METROPOLITAN GOVERNMENT OF NASHVILLE AND DAVIDSON COUNTY

STAFF RECOMMENDATION
1811 Beechwood Avenue
August 19, 2020

Application: New Construction—Addition and Outbuilding (DADU); Setback Determination; Demolition—Partial
District: Belmont-Hillsboro Neighborhood Conservation Zoning Overlay
Council District: 18
Base Zoning: RS7.5
Map and Parcel Number: 10416025300
Applicant: Martin Wieck, Nine12 Architects
Project Lead: Melissa Sajid, Melissa.sajid@nashville.gov

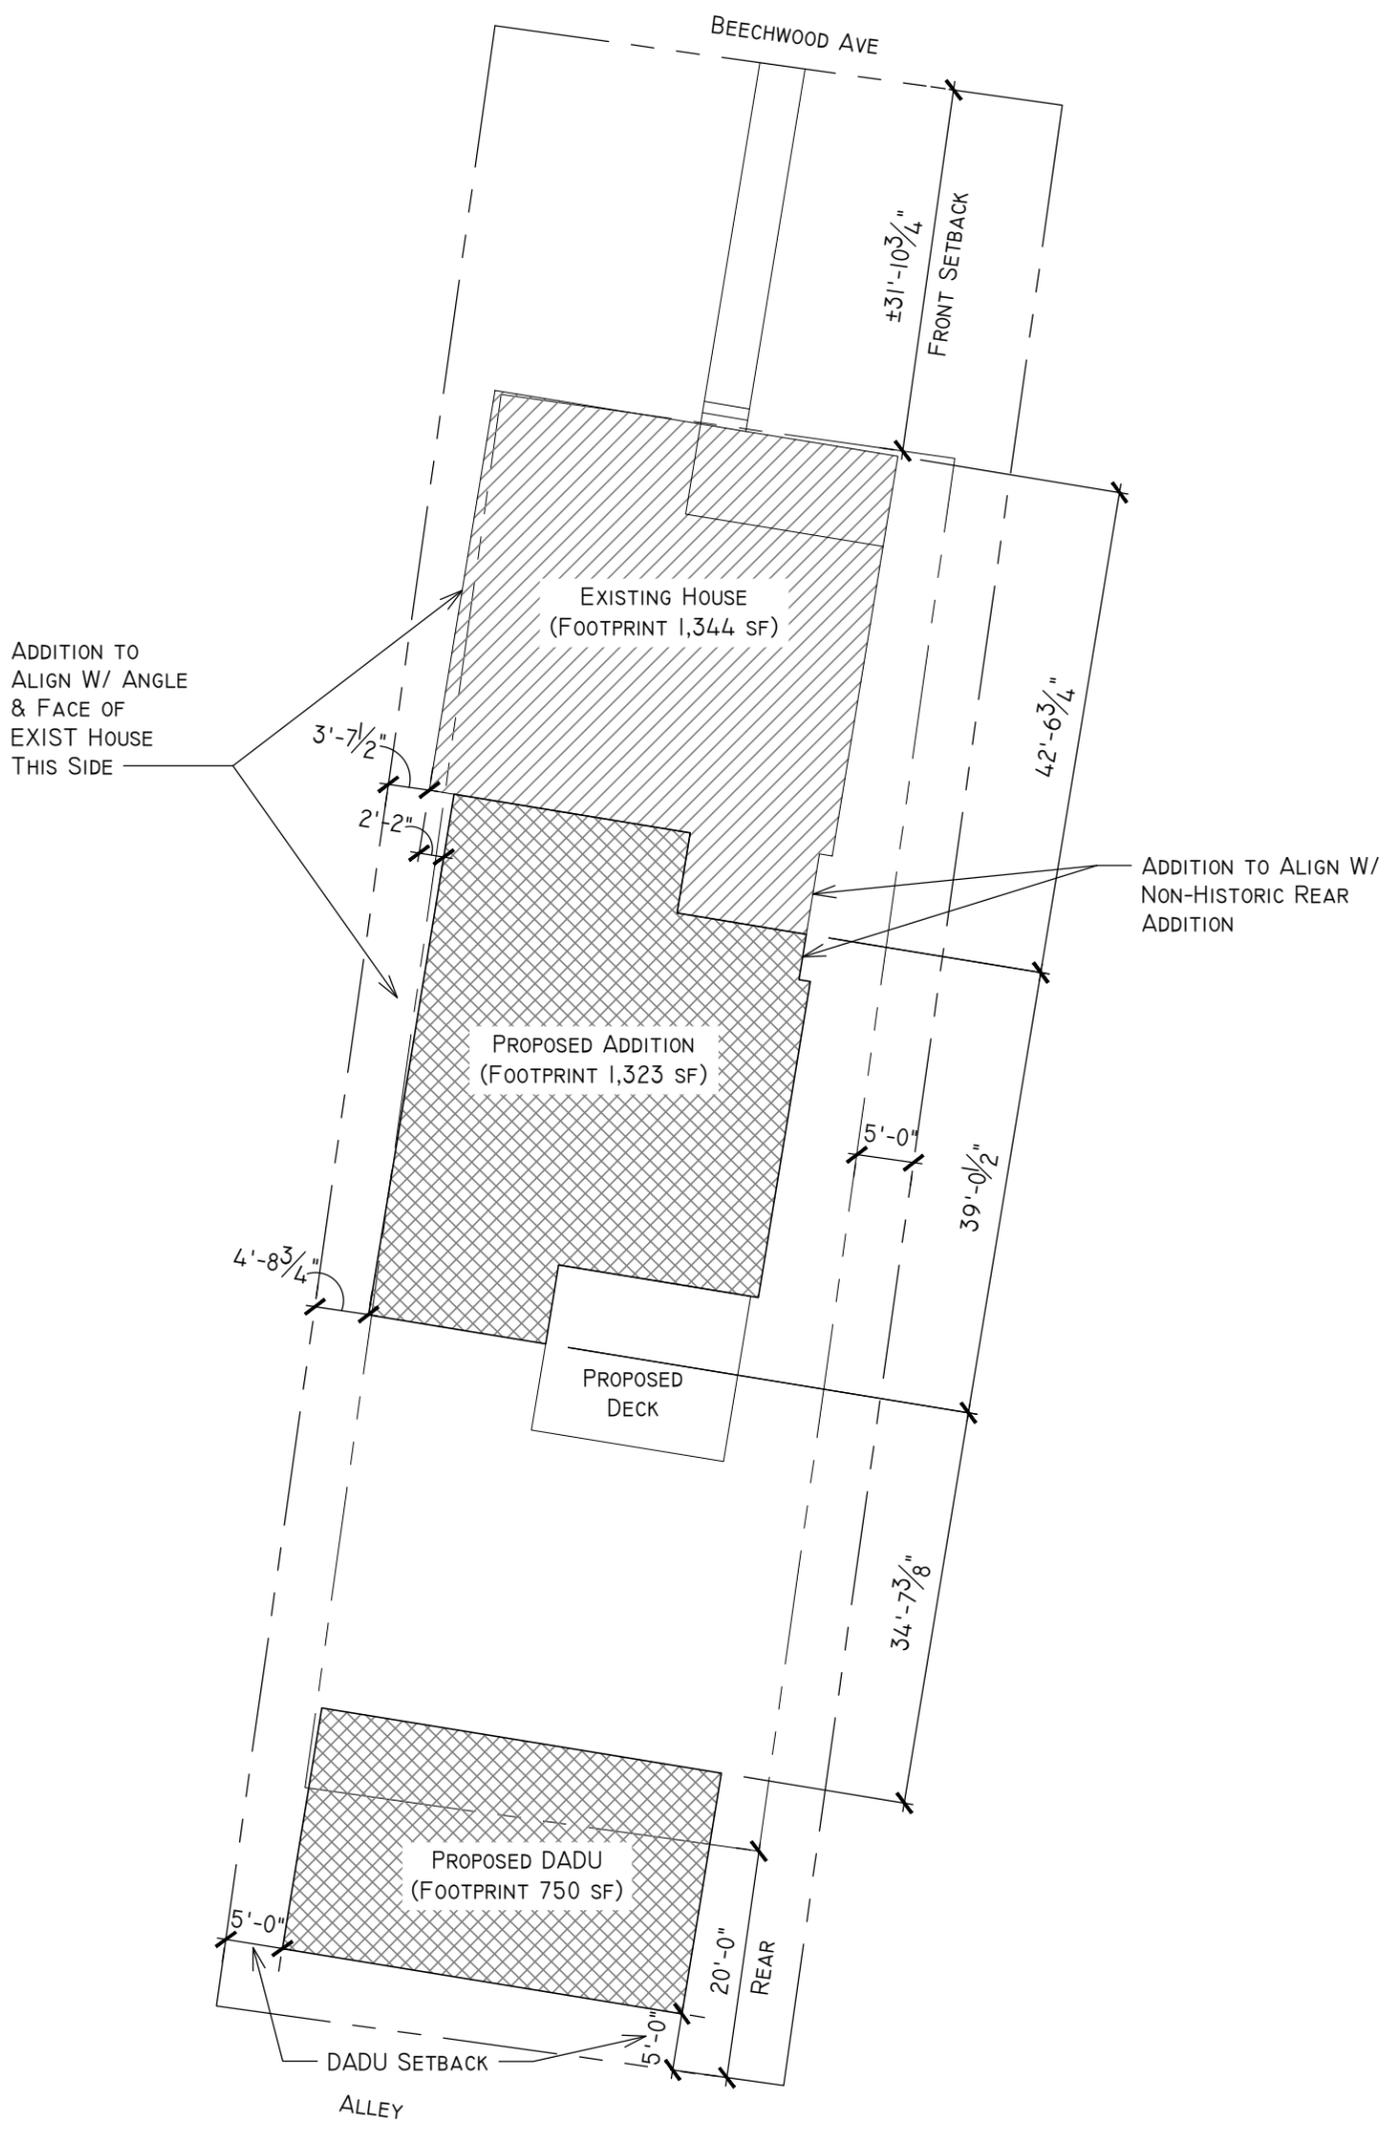
Partial Demolition: The applicant proposes to demolish an existing two-story partial width rear addition and rear dormer (Figure 2). While the two-story rear addition appears on the 1951 Sanborn map (Figure 3), staff finds that it is likely a later addition given the location, inset, change in material, and separate roof form. Given the location and design, staff finds that the addition is not a character-defining feature and its demolition meets the design guidelines for appropriate demolition.

The applicant also proposes to replace an existing door opening on the left-side façade of the historic house with a window (Figure 3). Since the altered opening is located beyond the midpoint and behind the chimney, staff finds that the partial demolition could be appropriate as it is unlikely to be highly visible, remains as an opening, and such a change is consistent with previous decisions of the Commission. For these reasons, staff finds the proposed partial demolition to be appropriate. Since the alteration will require patching the wall below the window with brick, staff recommends that the masonry and mortar color and tooling match the existing and that painting of masonry is inappropriate.

The project meets Section V.2 for appropriate demolition and does not meet Section V.1 for inappropriate demolition.
